Permit Number: 060702

This is to certify that Wilson, Gary & Simonetta/English & Hammer Inc/ Phil Requ
has permission to build a 46' x 55' single story 2 car garage Family Home
AT 539 ATRURN ST 382A D021001

City of Portland, Maine - Building or Use Permit Application

ONE AND TWO FAMILY		PLAN REVIEW		CHECKLIST	
Soil type/Presumptive Load Value (Table R401.4.1)		Submitted Plan		Findings	Revisions
Component		Date			
STRUCTURAL					
Footings Dimensions/Depth (Table R403.1 & R403.1(1), (Section R403.1 & R403.1.4.1)		8' 8"x24"			
Foundation Drainage, Fabric, Damp proofing (Section R405 & R406)		4" drain/stave/damp proof		① Need fabric ① Heavy nylon wrapped pipe ② Asphalt cement seal	
Ventilation/Access (Section R408.1 & R408.3) Crawls Space ONLY		N/A		② Need 4' frost wall	
Anchor Bolts/Straps, spacing (Section R403.1.6)		1/2"x10" 24" oc - OK		for garage	
Lally Column Type (Section R407)		Lally Beams		Foundation	
Girder & Header Spans (Table R 502.5(2))		9'4" Floor			
Built-Up Wood Center Girder Dimension/Type		2x6 PT			
Sill/Band Joist Type & Dimensions		2x12's - 16" oc			
First Floor Joist Species Dimensions and Spacing (Table R502.3.1(1) & Table R502.3.1(2))					
Second Floor Joist

ROOF FRAMING PLAN

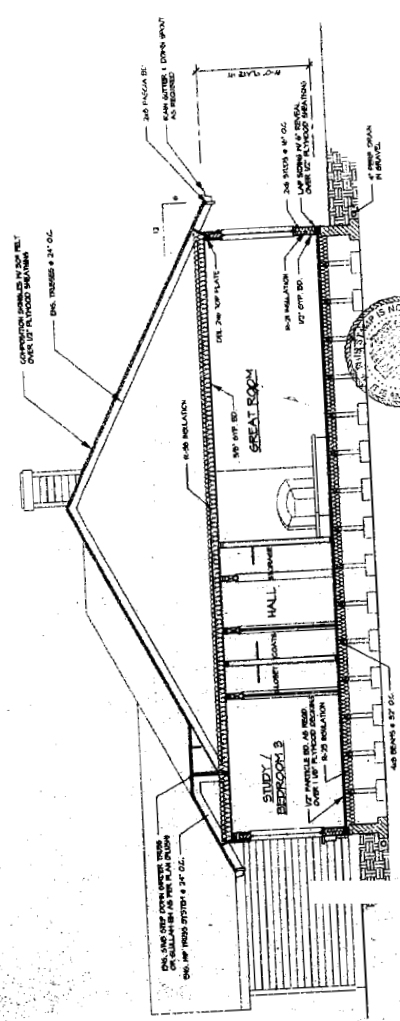
13) Root beam on covered patio is not large enough. 3 2x10 header

FRONT ELEVATION

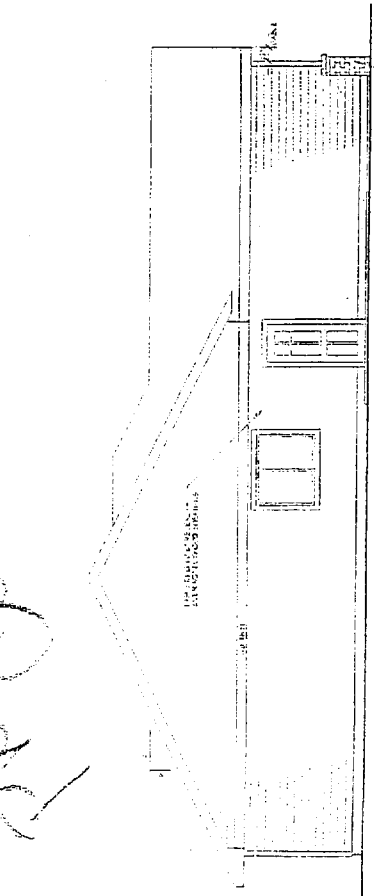
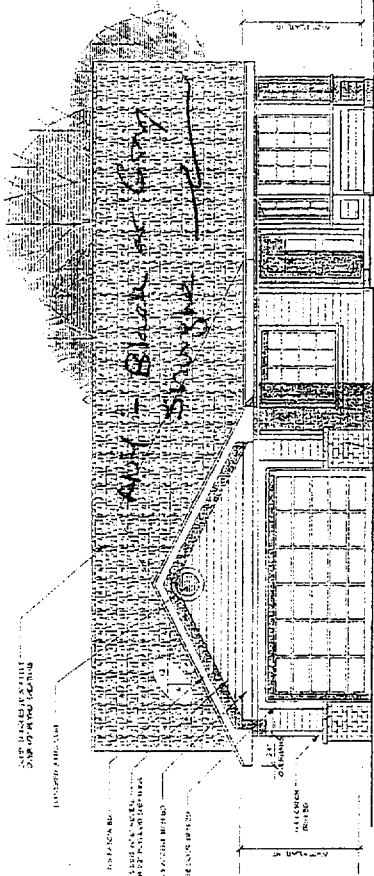
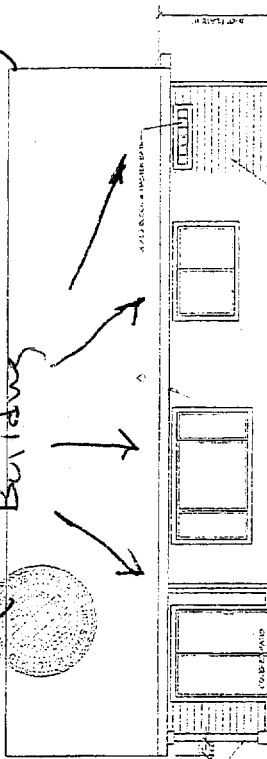
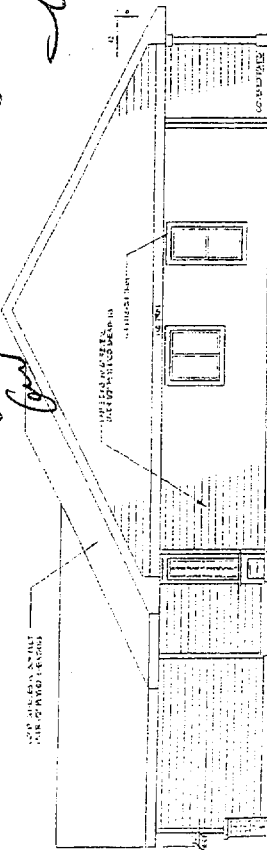
Typical - Crown welding over all Doors & windows (with Stoppers).
3 1/2" Trim AT HEAD OF WINDOW AND AROUND ALL DOORS
including over head doors. (NOT REQUIRED AT REAR OF
S.W.)

~~NOTE~~ ANY WINDOWS WITH OUT SHUTTERS
MUST HAVE 3 1/2 TIMING ON SIDES
AND HEAD. REAR IS EXEMPT

~~K~~ S. W. Good
